**Project Description:** Commercial Plaza – Phase 1 (1 Building Pad as per the LLWS + 5 Buildings Base building)

**Project Address: 1300 Fanshawe Park Rd E, London, ON N5X 3Z8.**

Based on RFIs received, and clarifications from consultants, please see below and Attached:

**RFI # 16 :**

### 2) DOLLARAMA - (CRU#1 UNIT - C)

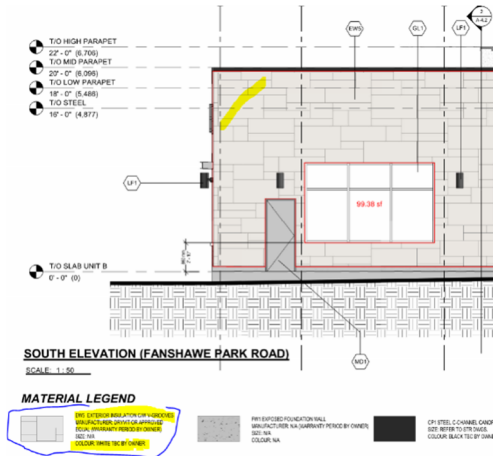
**a) the attach shows the paint to be done behind parapet, please confirm if it should be taken in consideration for pricing, if yes, then is it just the finish coat?**

- Response: Tenant to confirm. Storefront is to include a parapet of not less than 50 feet in width and 6 feet in height with necessary access for electrical signage connections for the Tenant’s signage. The parapet behind the Tenant’s sign shall be painted or otherwise colored Benjamin Moore - Rainforest Foliage 2040-10 (Dollarama Green). The parapet shall be subject to the Tenant’s prior approval.

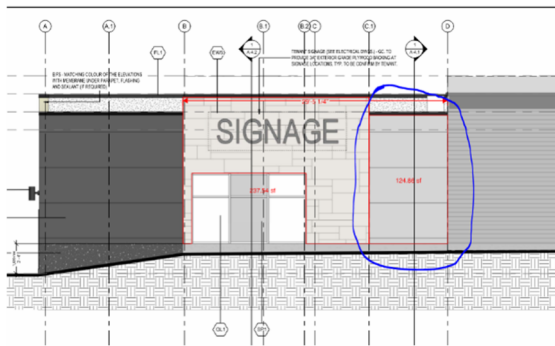
**b) hatch missing on the marked area, which material to consider?**

- Response: The material to be considered in marked area is EW7.

**4) CRU #5**

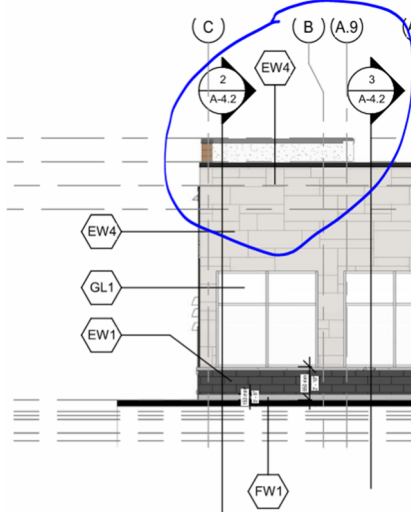
**a) elevation shows discrepancies with materials, legend mentions EIFS. Confirm the material.**

- Response: Indicated material is EIFS. Contractor to provide alternative pattern. Client to review and confirm.

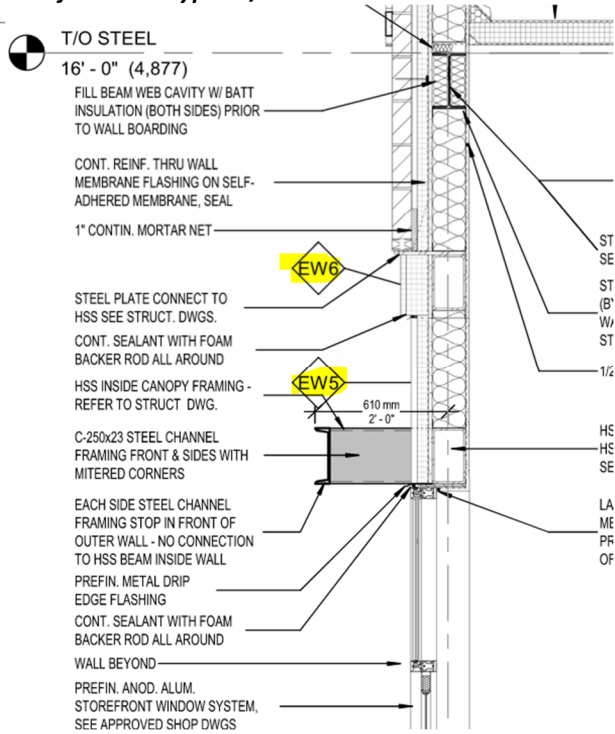
b) **Need clarification on material on the basis of wall assembly and elevation because material shown is different from wall type as/ section.**

- Response: Material showed on section 3, marked as EW5 to be EW2. Please refer to Sheet A-4.1.

5) **CRU #6**

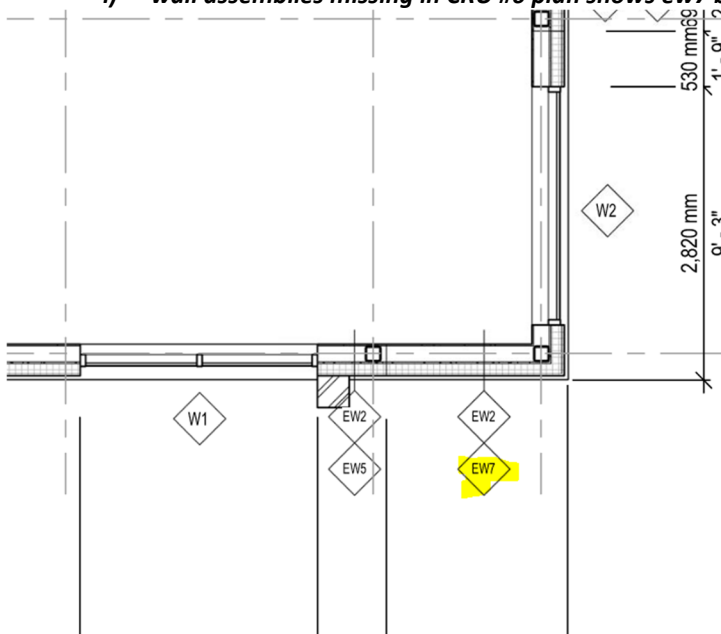
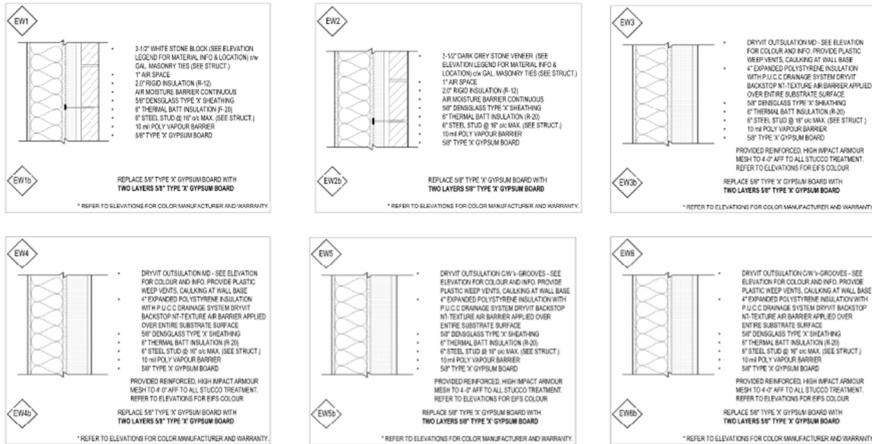
i) **wall assemblies missing in CRU #6 plan shows ew7 but not shown in wall assembly.**

- Response: Incorrect Wall tag. EW7 to be EW6. Please refer to Sheet A-2.2.

**6) CRU #7**

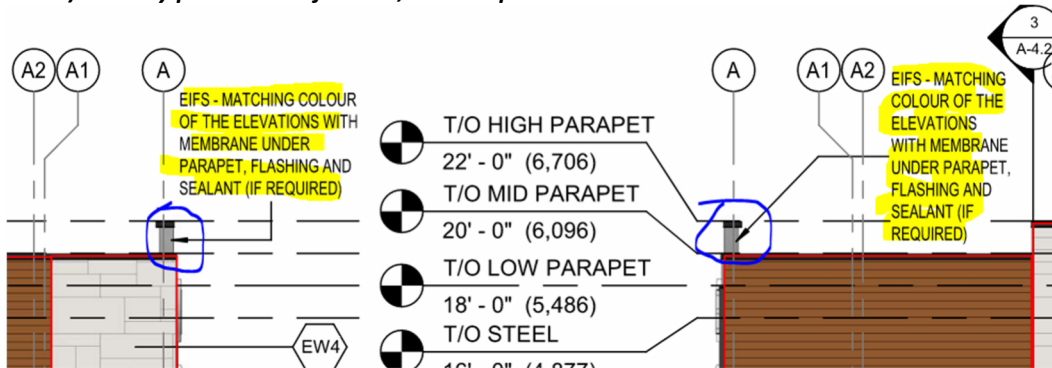
**a) Kindly provide clarification, is there paint to be done at the back?**

- Response: Provide EIFS matching colour of the front elevation on side of parapet for consistency. back side to maintain without paint.

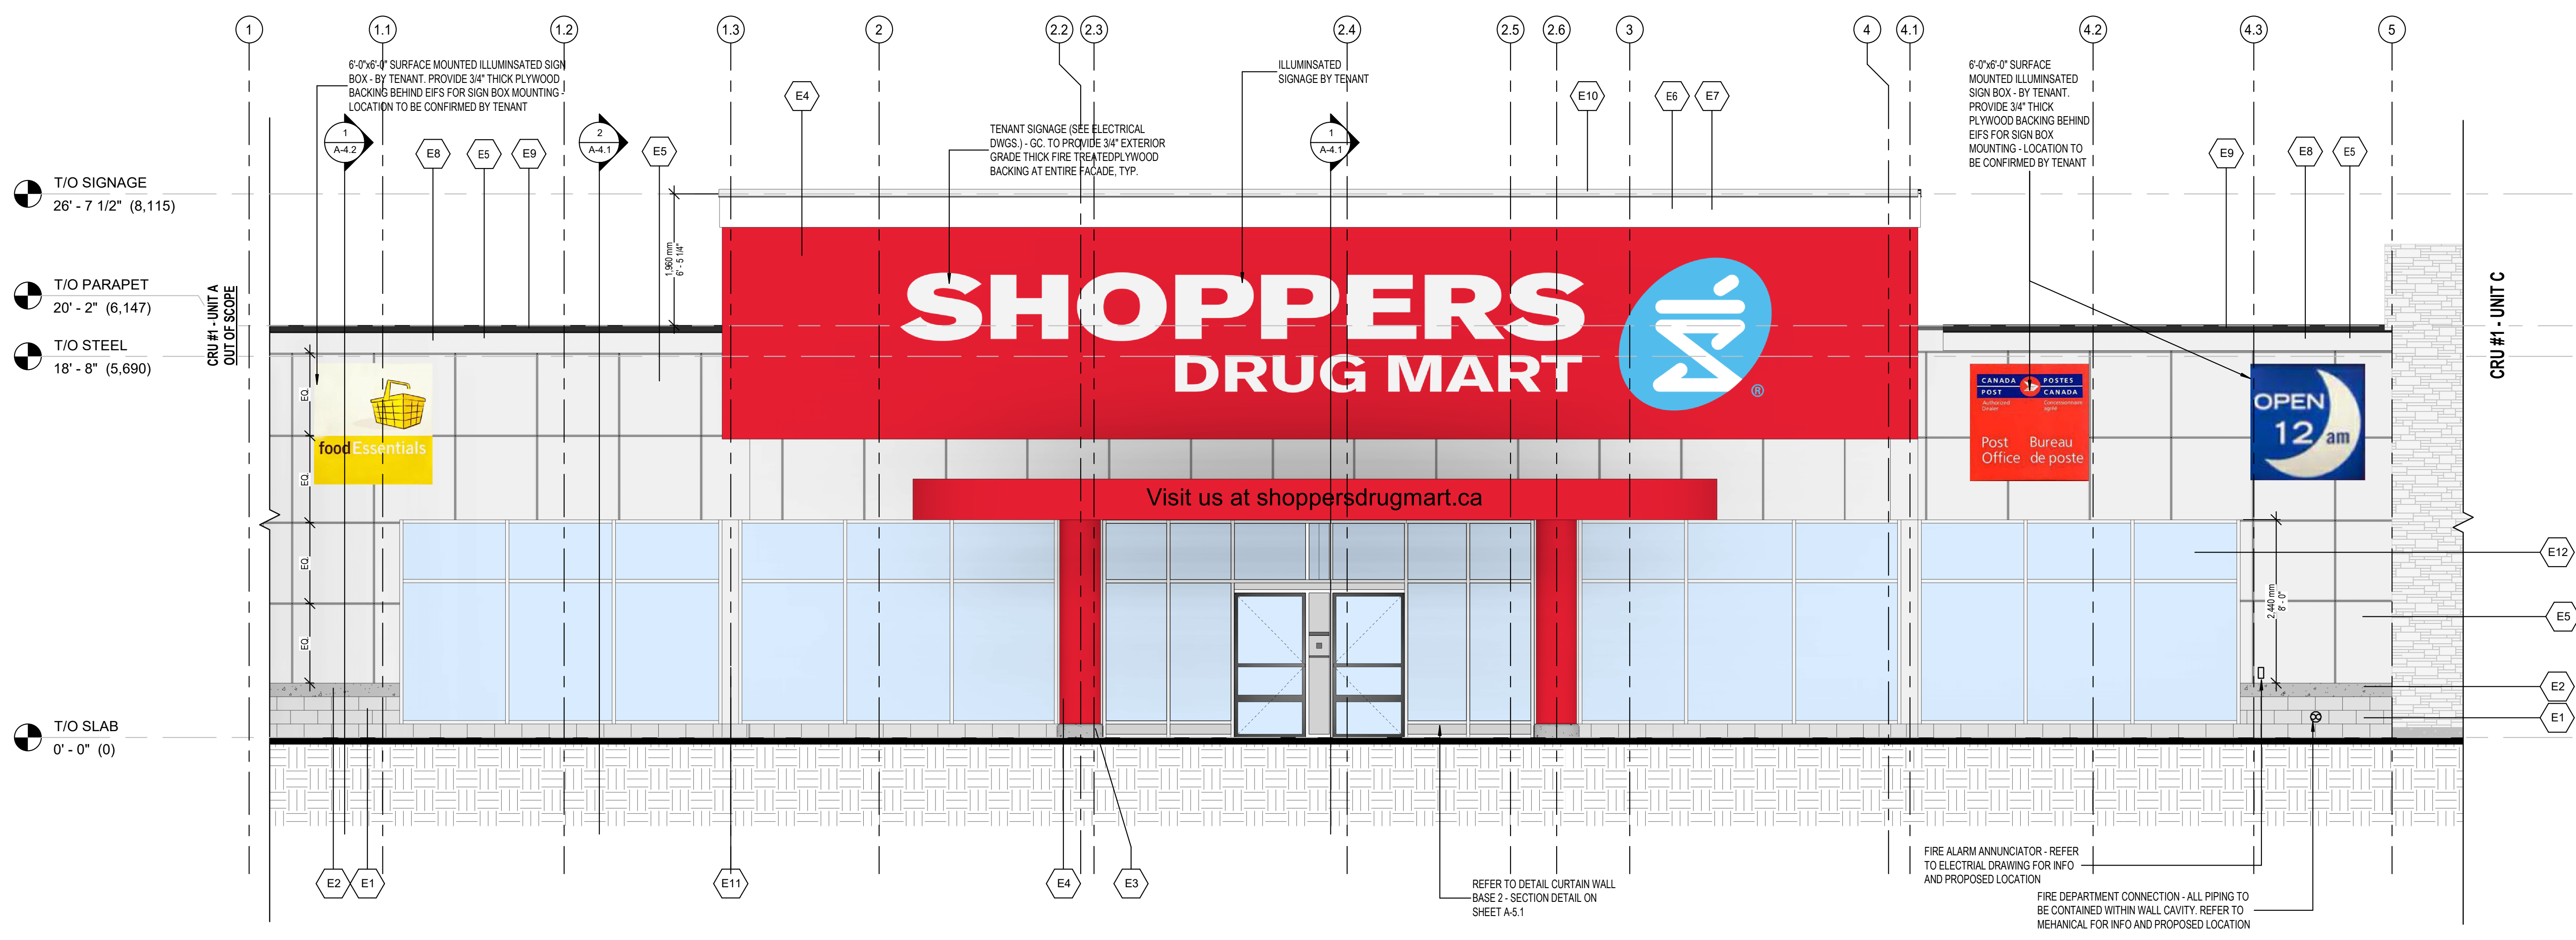
**d) what will be the standard size for precast stone sill. Moreover, precast stone sill hatch makes it look like concrete. Please clarify if concrete or stone.**

- Response: Shouldice Stone, 3 ½" thickness precast stone sill. Contractor to provide alternative option and Client to confirm.

**A-3.1 6**

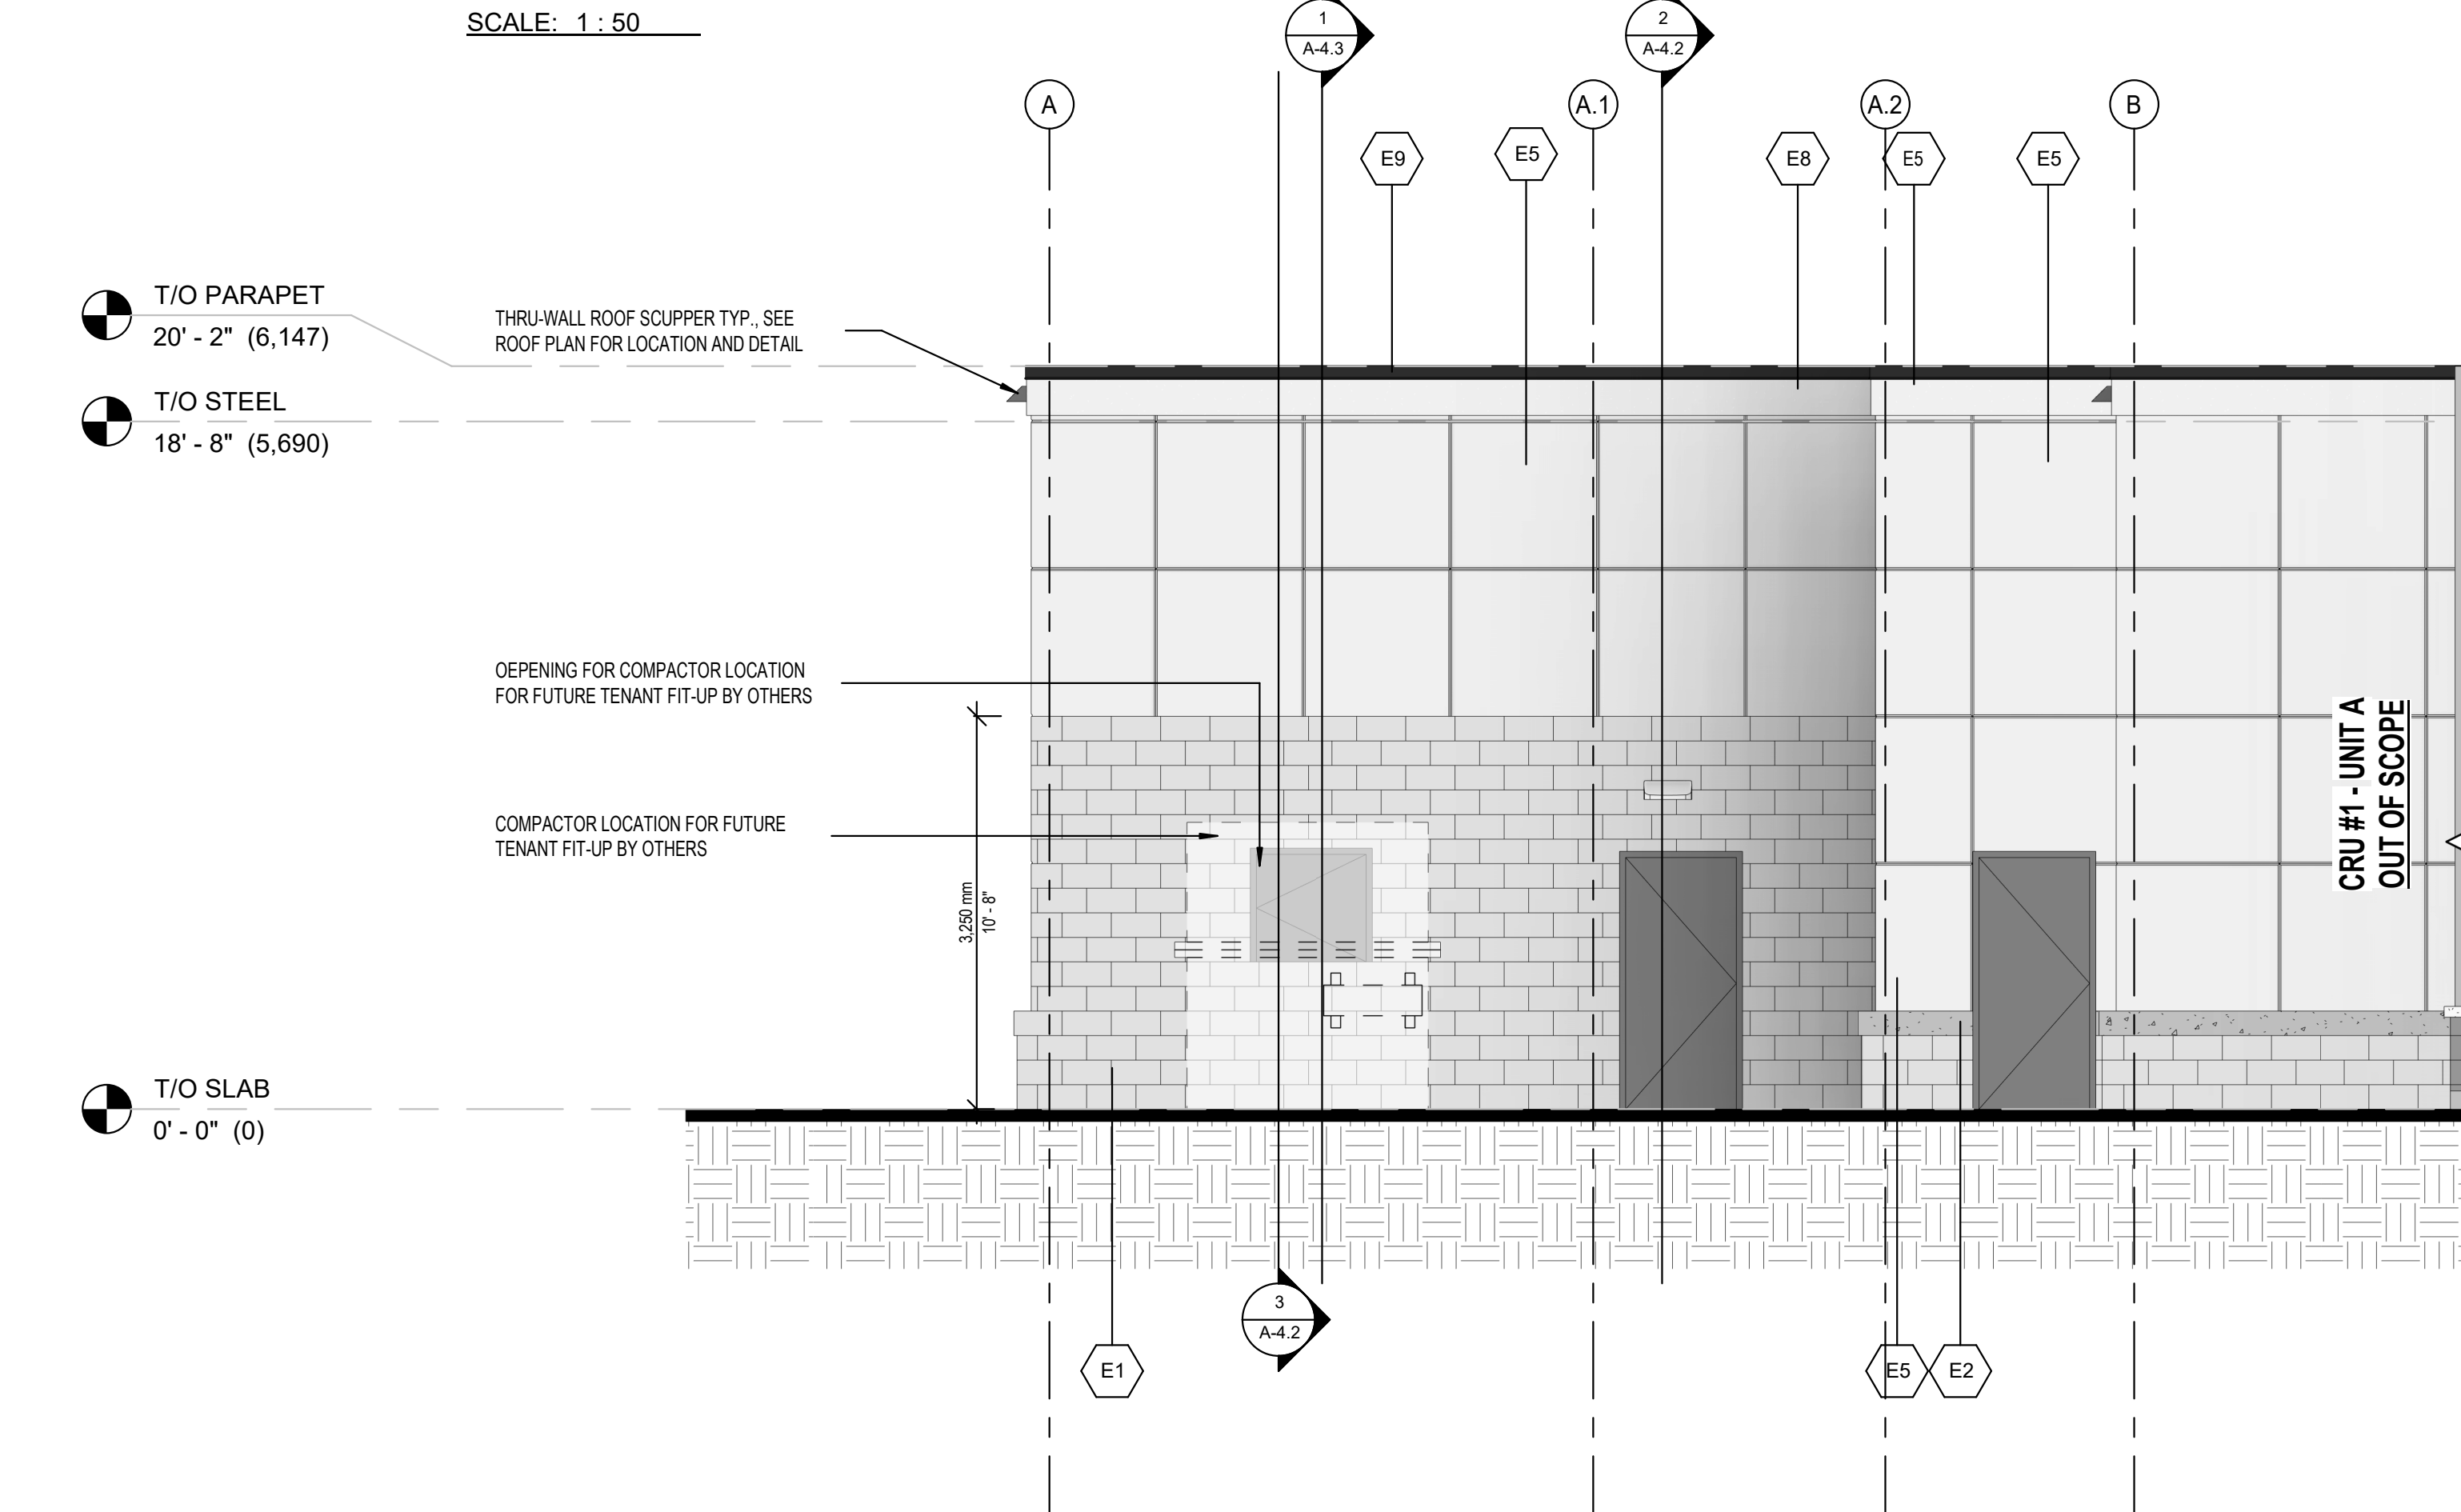
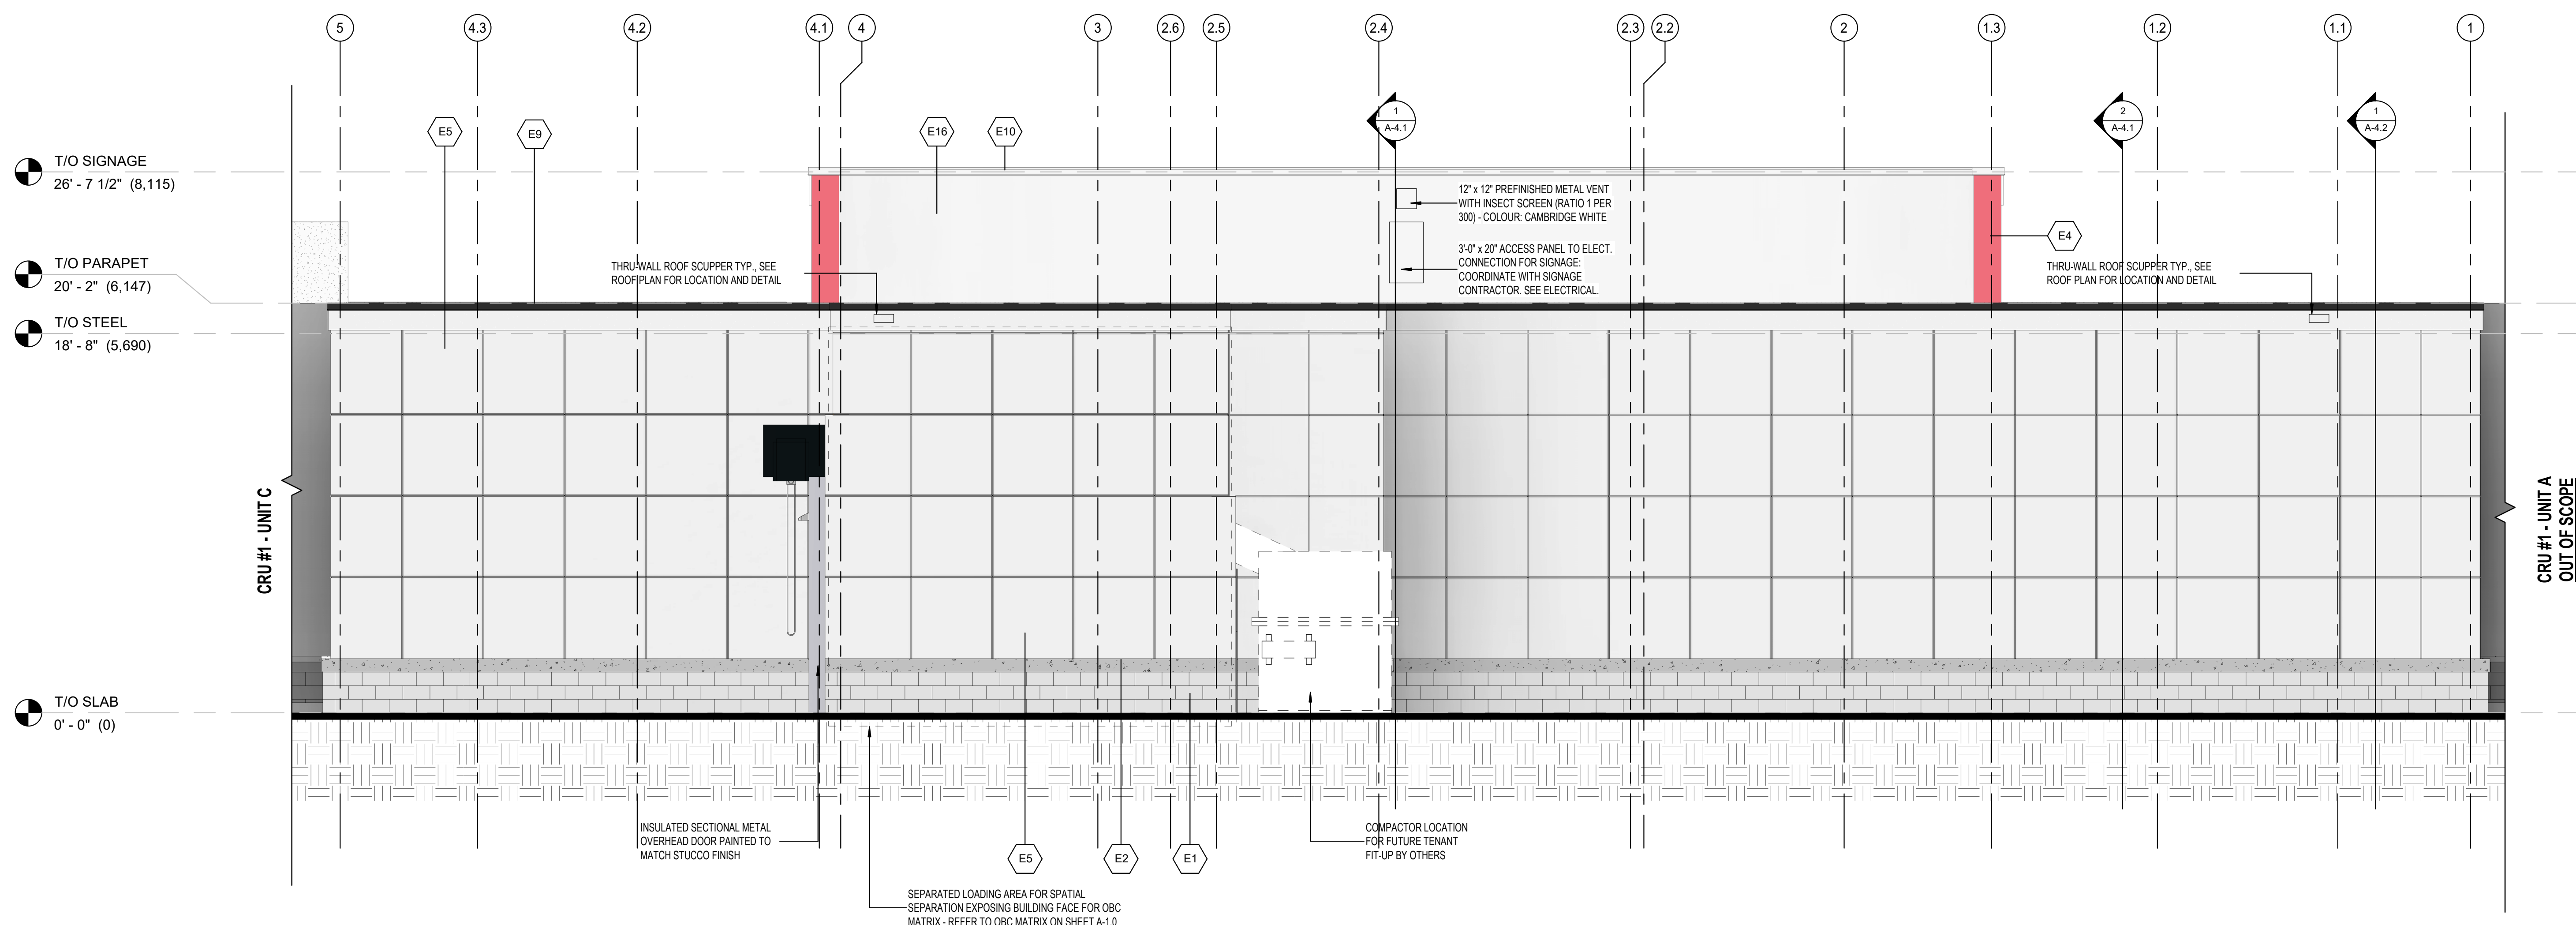
**a) legend texts are overlapping all through the legend chart. However, the image attached shows the finish type for precast concrete sill is unclear due to overlapping text. Please clarify.**

- Response: Refer to revised sheet A-3.1 & 3.2. Material Legend has updated.
